Homework 3: Scan testing and LFSR
Student reference

Cedar-8f2c

Student reference. This is an anonymous, editable reconstruction of the supplied student report. It preserves the student's approach and reported results. Editorial verification notes and assignment clarifications are labeled separately. It is not a newly corrected solution or a claim of full fault coverage. The accompanying anonymized PDF preserves the original evidence.

Figure 2: Editable reconstruction of the six-bit LFSR diagram.

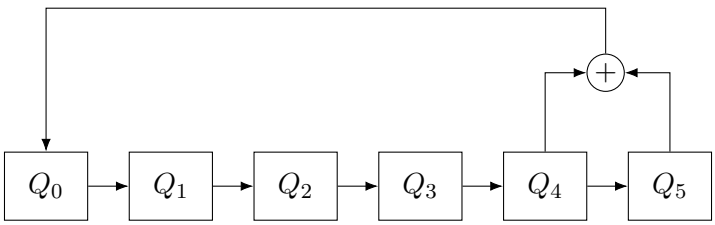
Editorial verification notes. The sum alone cannot prove uniqueness, since repeated values can have the same total. A stronger check should track each of the 64 possible states and verify the expected period. The retained recurrence never reaches the all-zero state from its nonzero seed, so it can generate 63 states, not the original PDF's 64-state exhaustive sequence. This matches the later supplementary announcement, but it is not a modified exhaustive 64-state generator.
